FURTHER OBJECTION TO PLANNING APPLICATION DM/25/3095

Proposed first floor rear extension to form bedroom, and a new porch and roof dormer to front elevation — 40 Gander Hill, Haywards Heath, RH16 1QX

Living Room: Direct Sunlight from South West Window on 13 December 2025 at 12:33

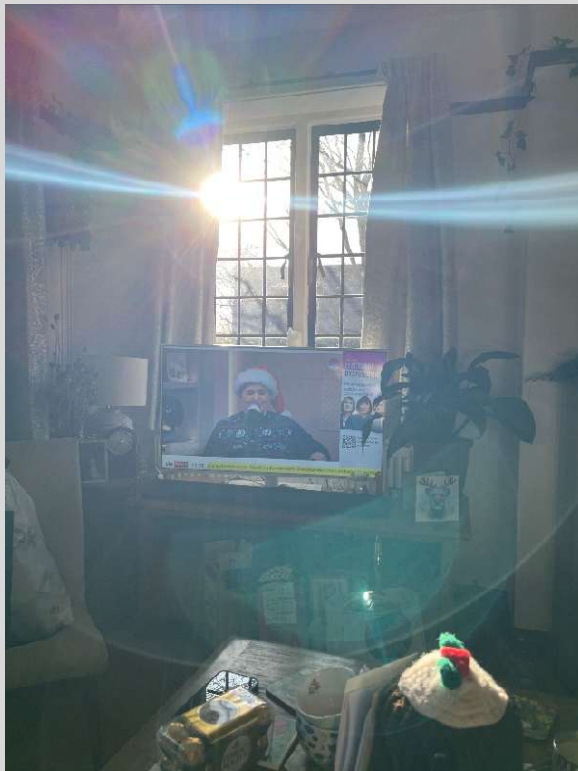
12:34 on 13 December 2025 – this sunlight would be blocked.

30 January 2026, 13.35 – sunlight from the SW window

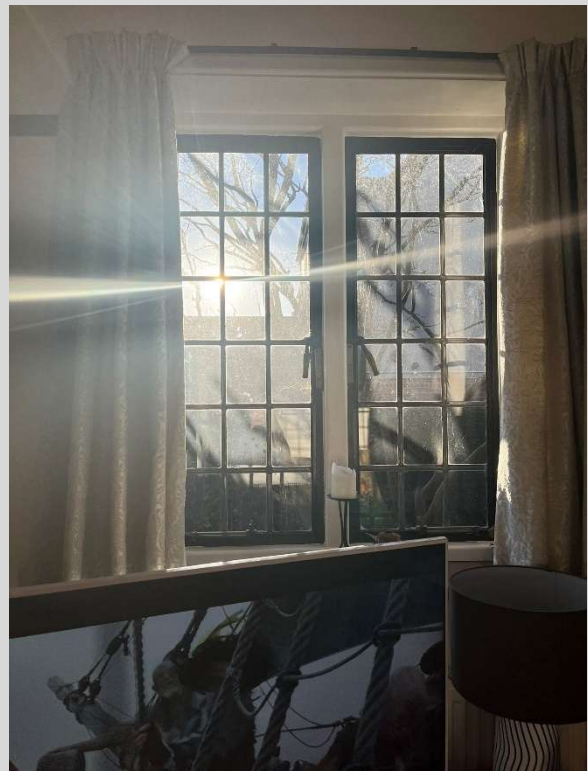
25 December 2025, 12.38 - sunlight blocked from this point onwards
